ADDENDUM NO. 2

Issue Date:	January 17, 2024
Project Name:	Sandridge Golf Club New Clubhouse
ITB Number:	2024029
ITB Opening Date:	**February 1, 2024**

This addendum is being released to provide answers to questions received to date, modify the bid documents, provide additional background documents, and provide minutes to the pre-bid meeting.

I-112

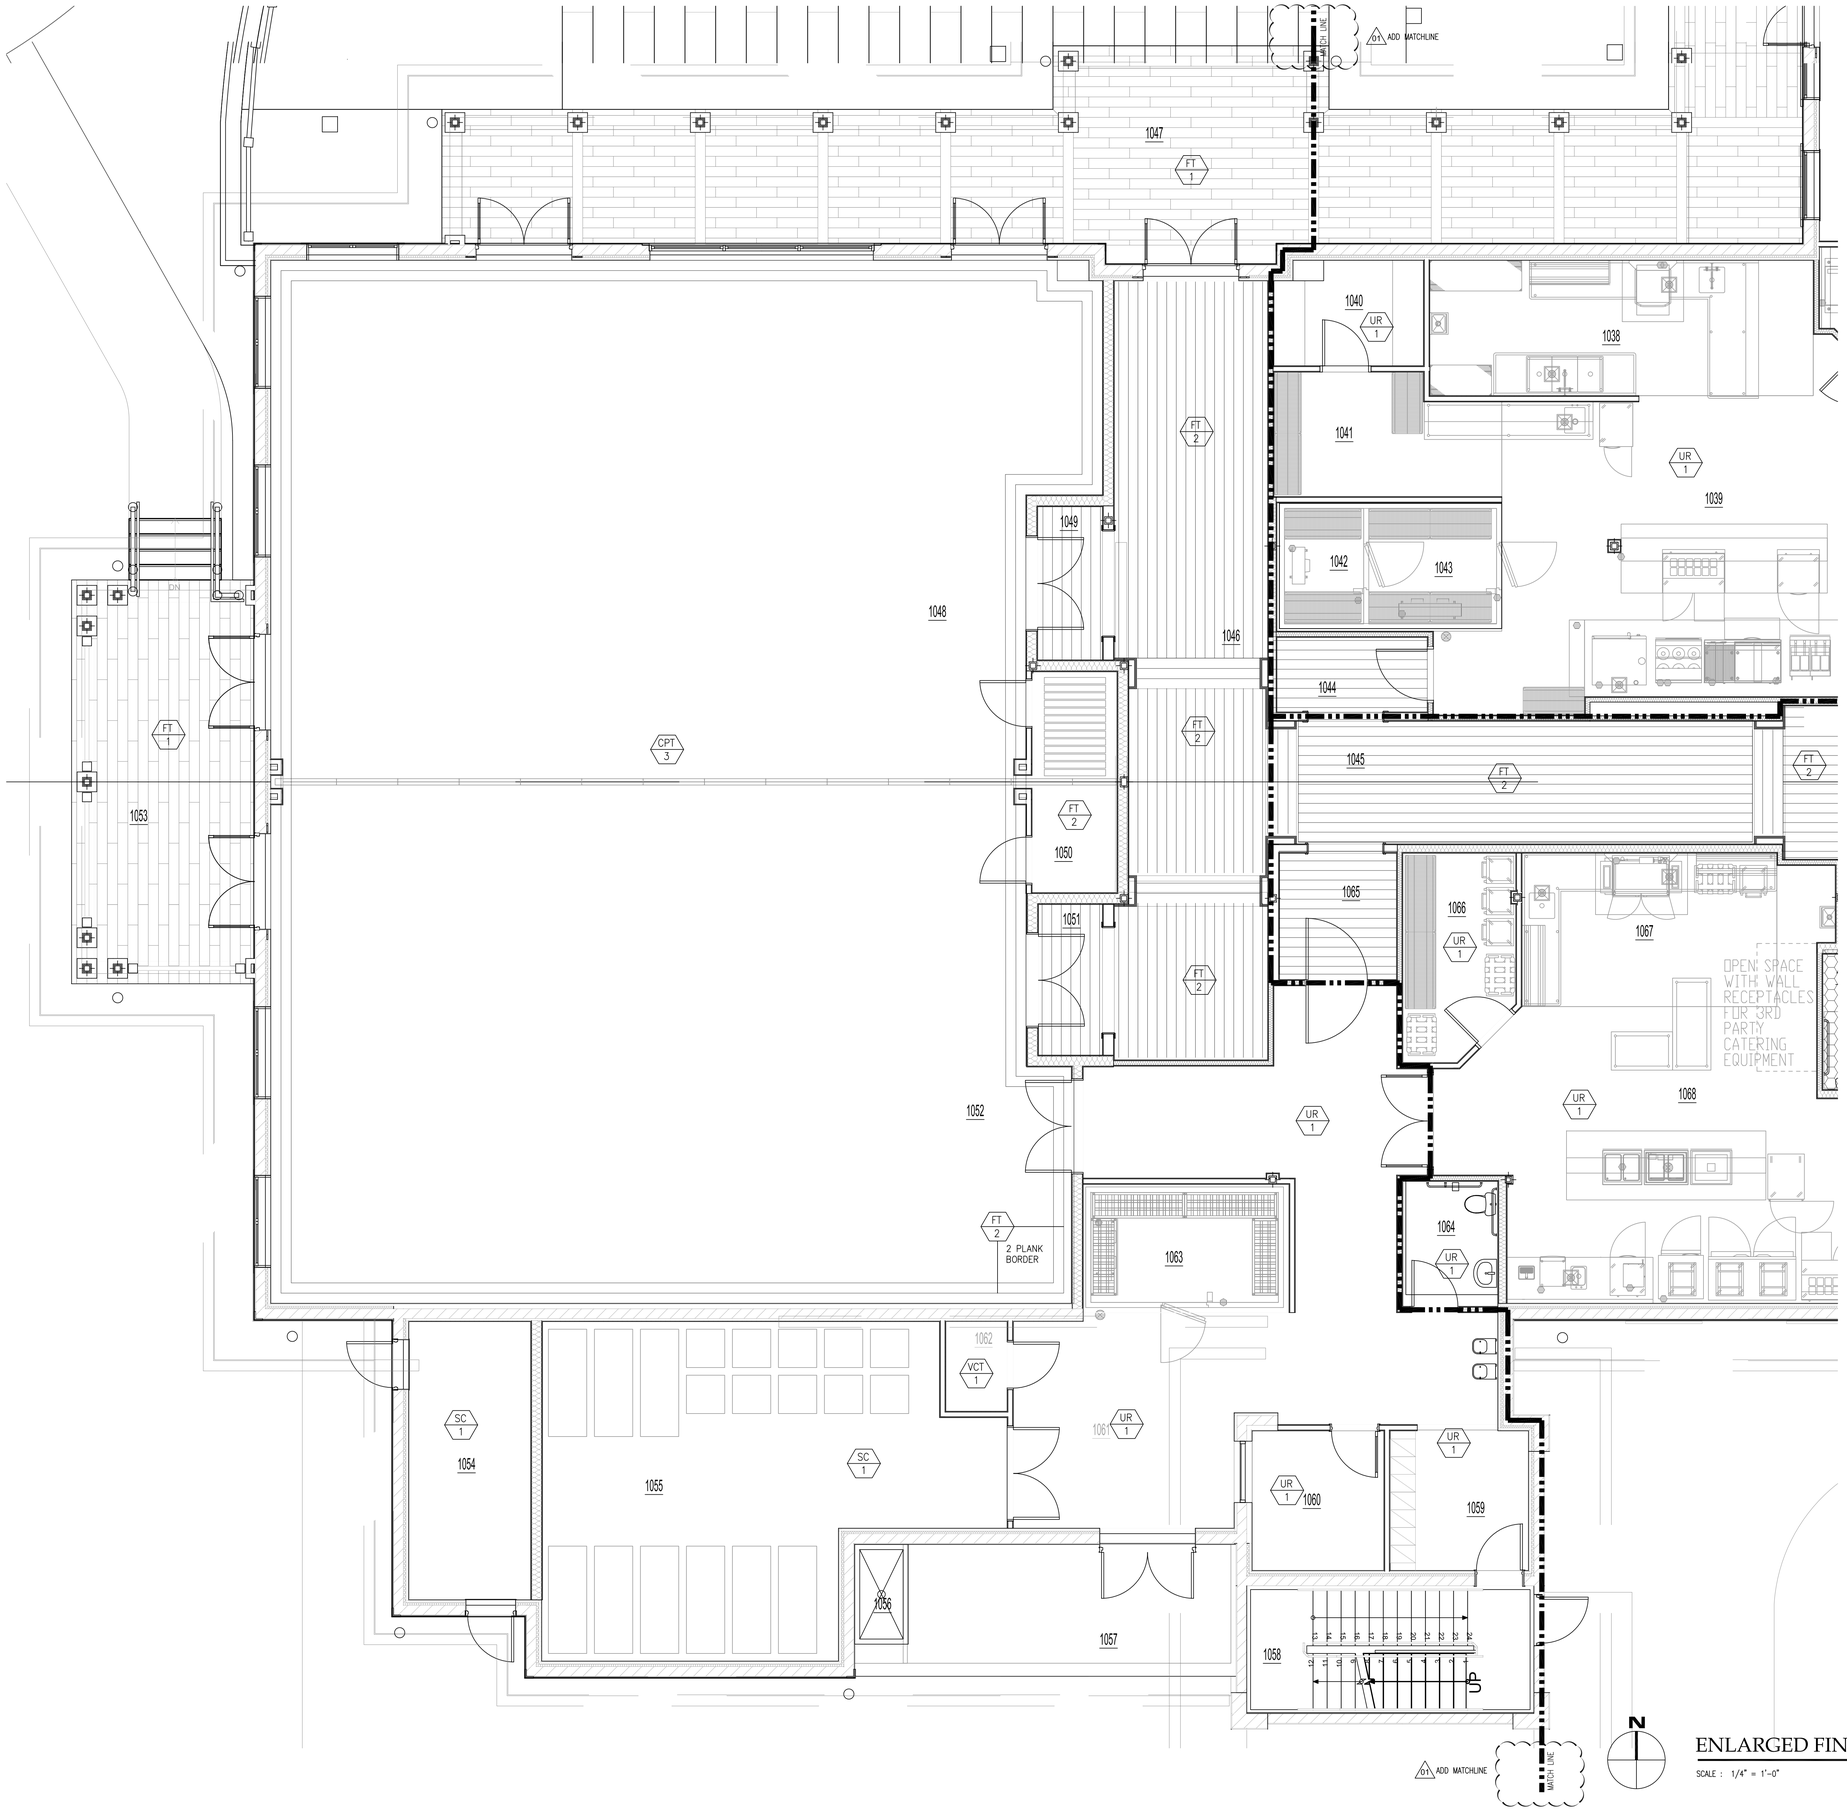
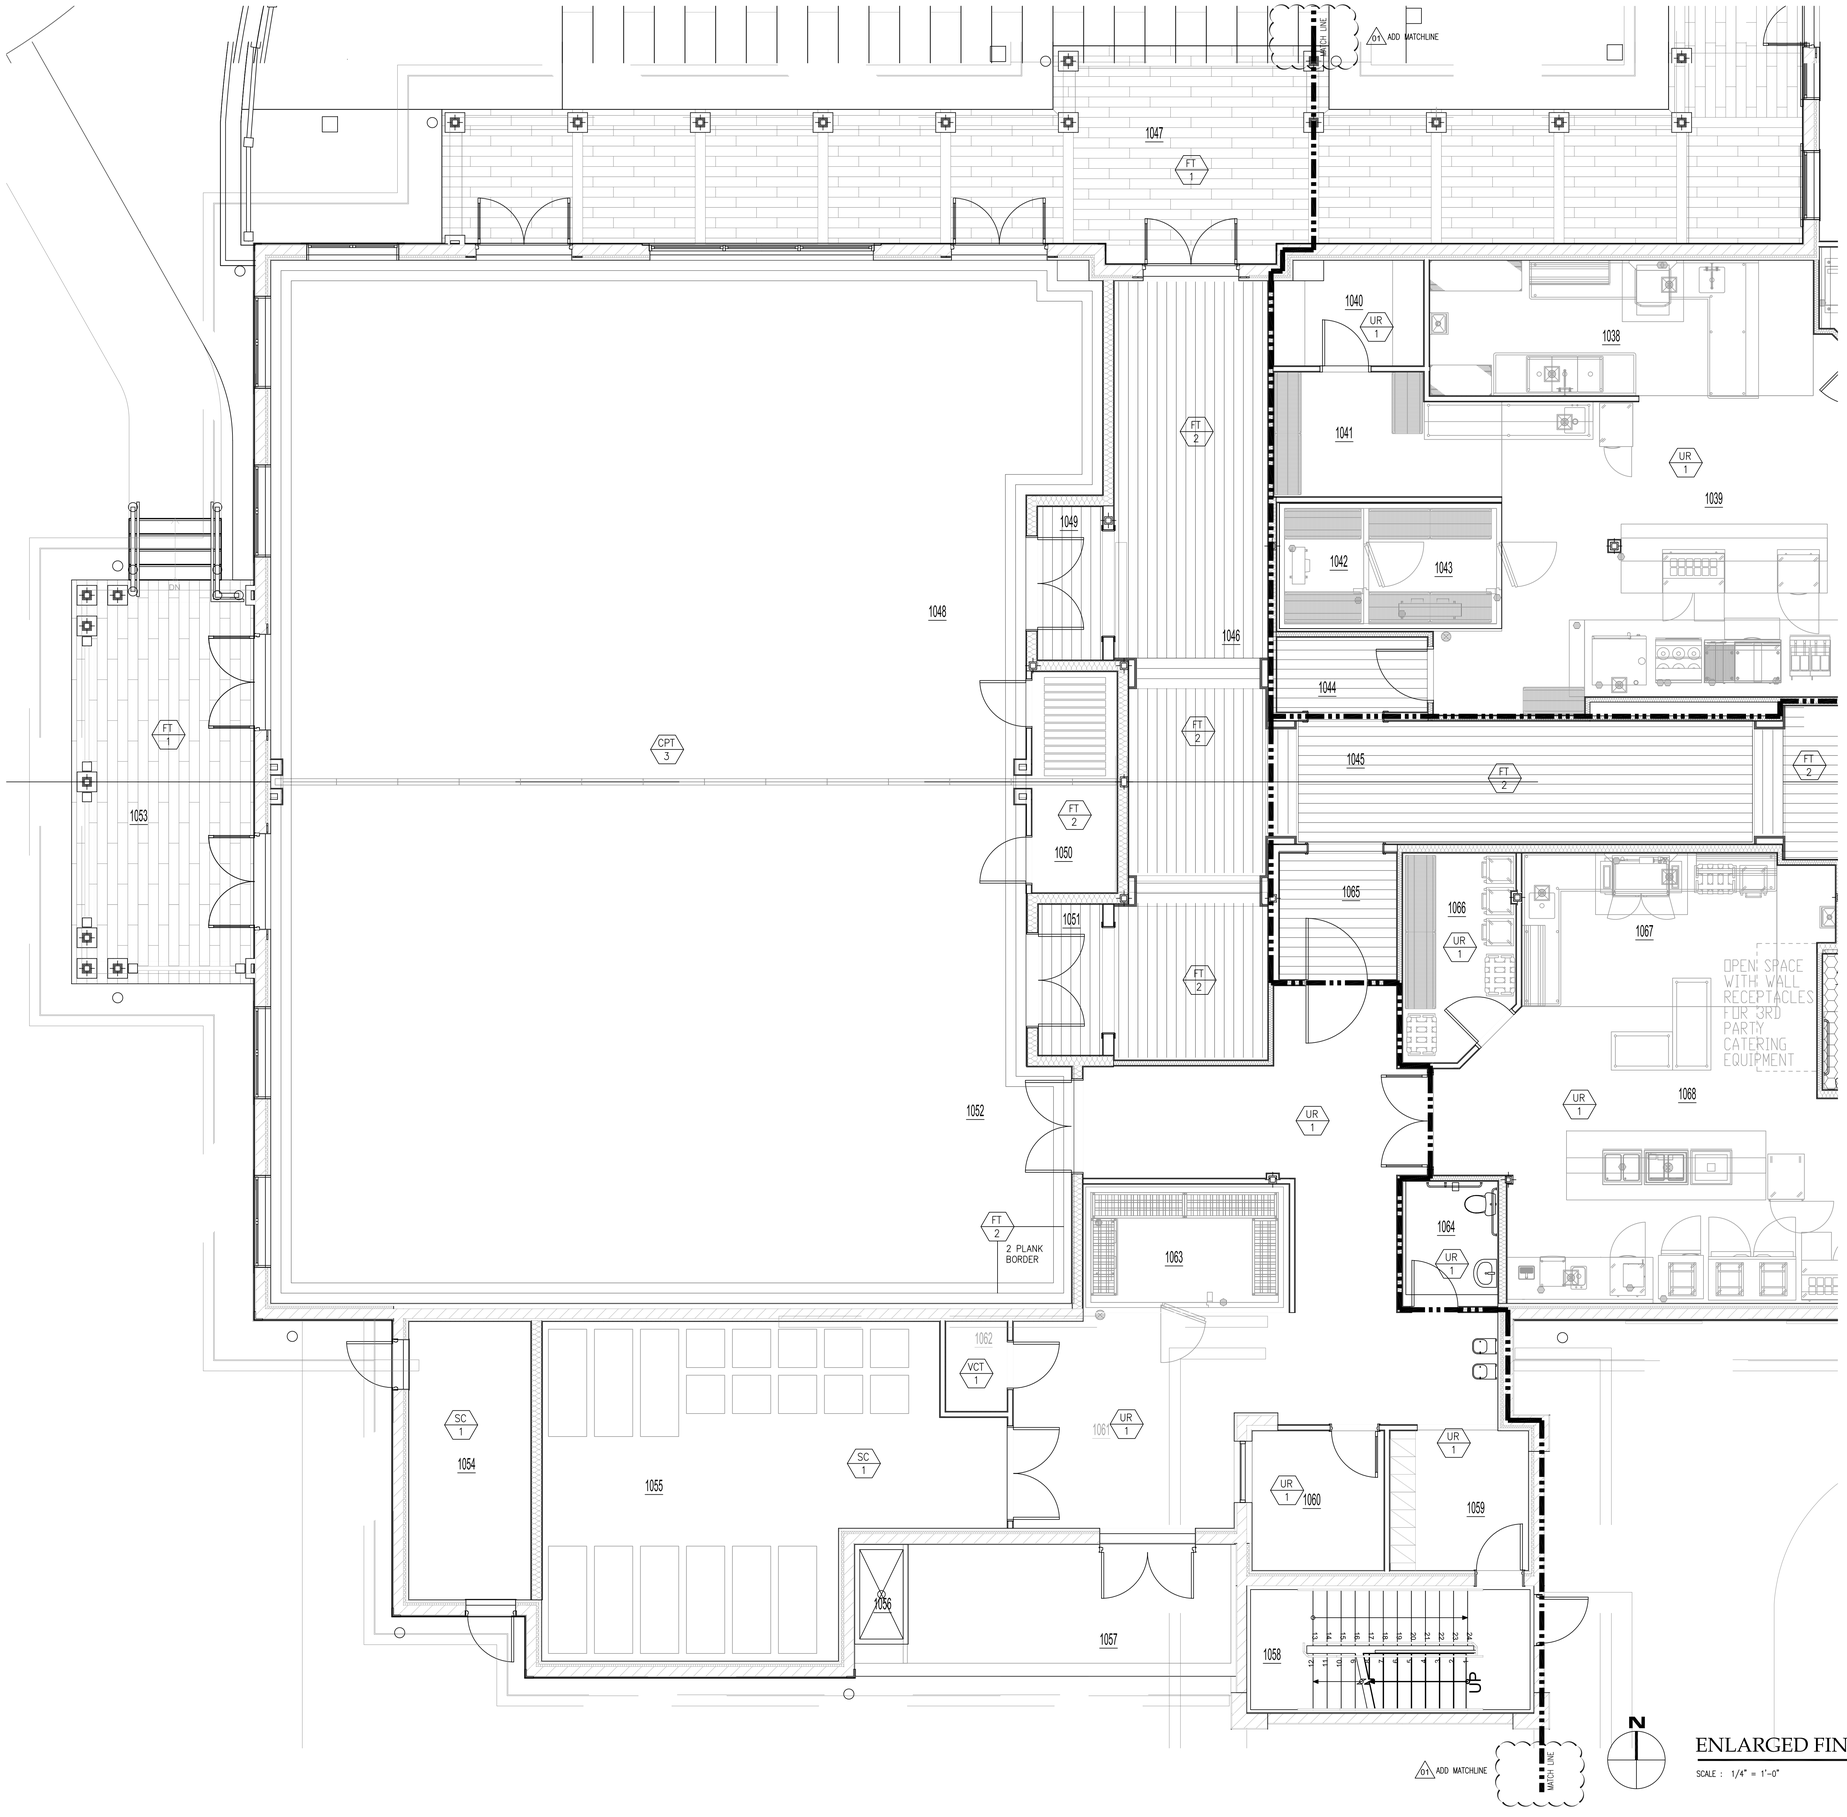
16. INTERIOR DRAWINGS I111-I113 HAVE NO PROVIDED MATCHLINE.
See revised sheets I111, I112 and I113 for added matchline.

ADD MATCHLINE

I216

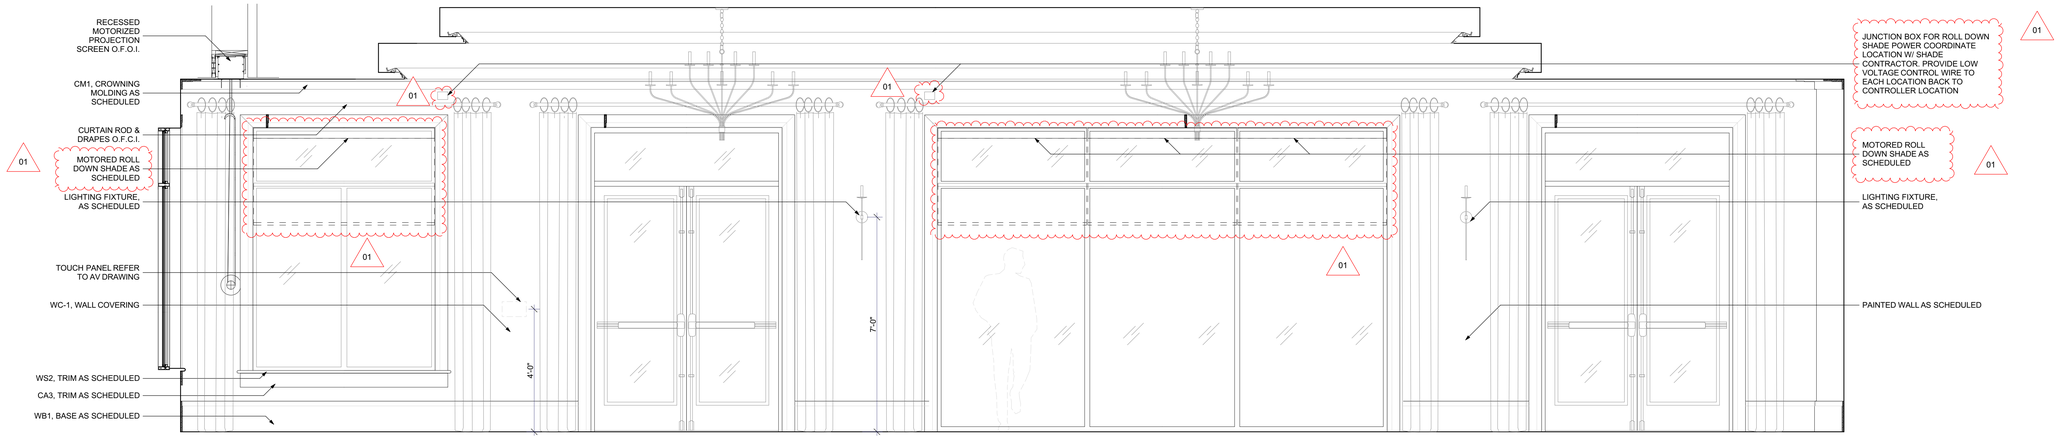
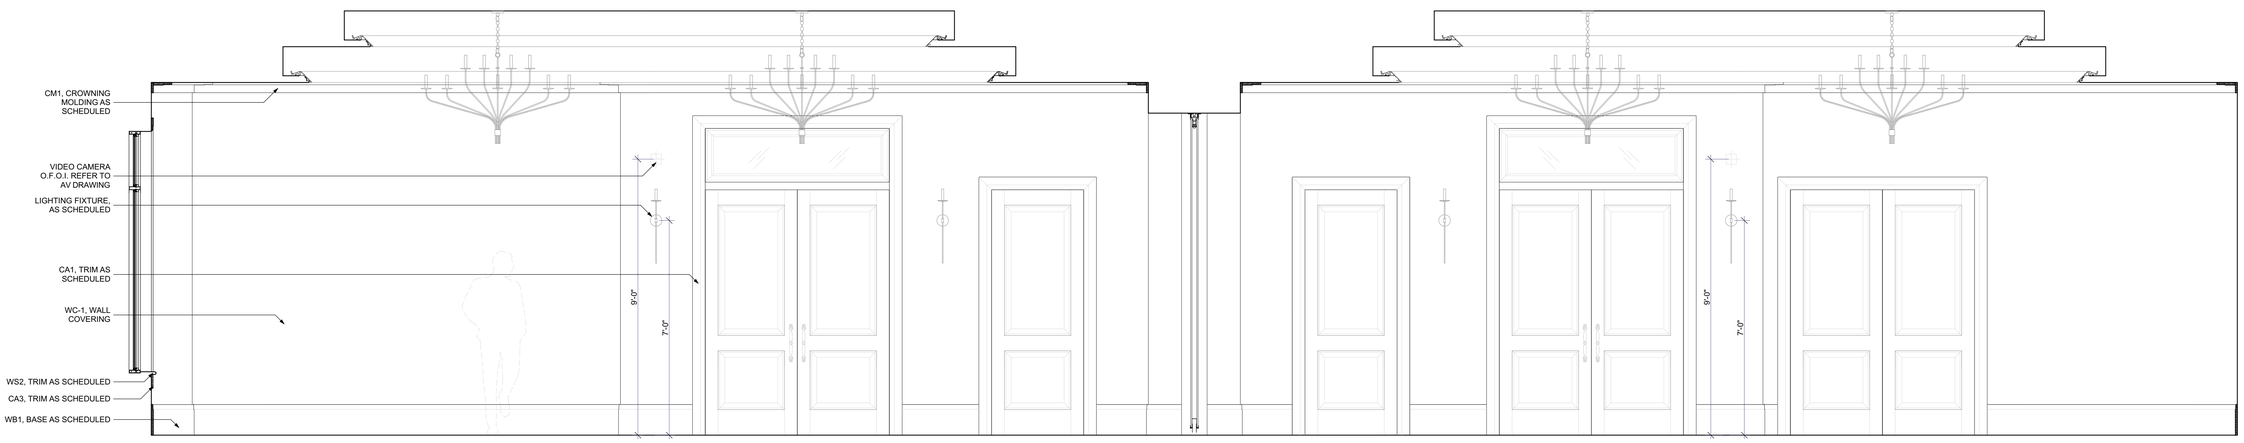
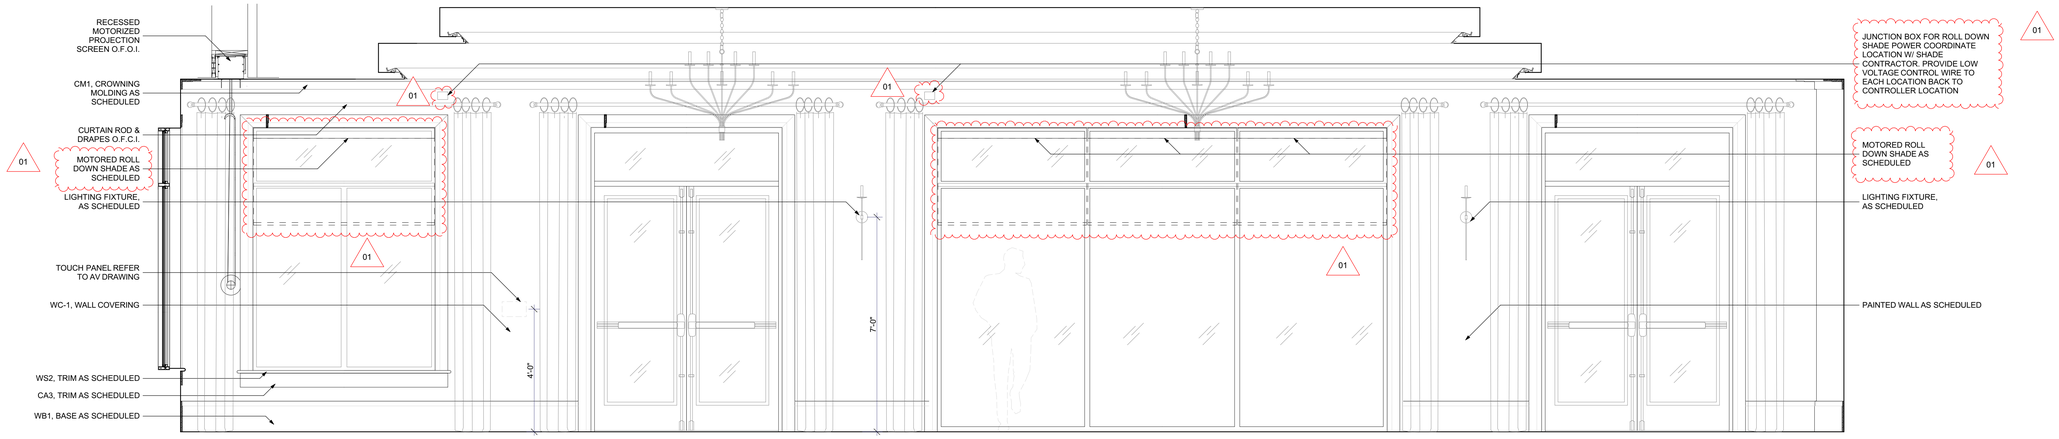
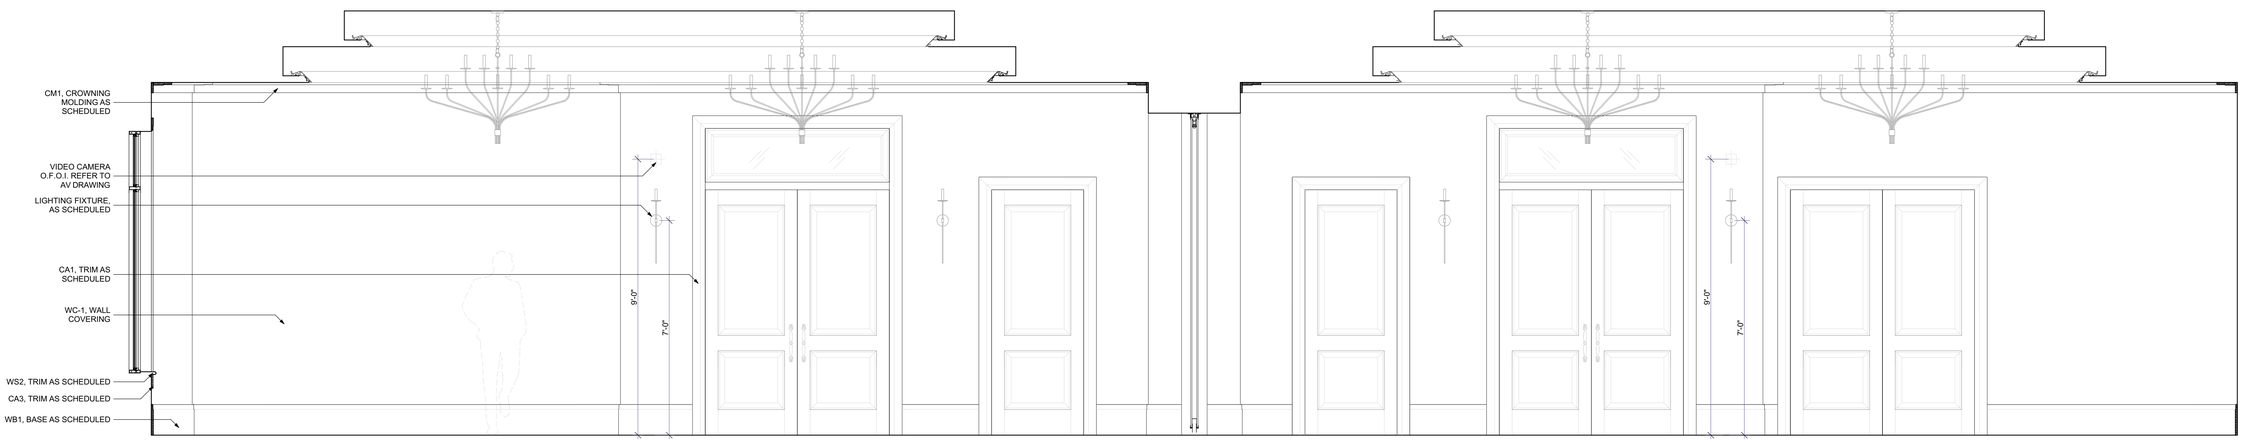
15. PLEASE CONFIRM THE ROLL DOWN MOTORIZED SCREENS ARE BY OWNER.
Roll down motorized screens are contractor furnished/contractor installed. See revised sheets A411, A605, A805, I216 and I217 for additional information.
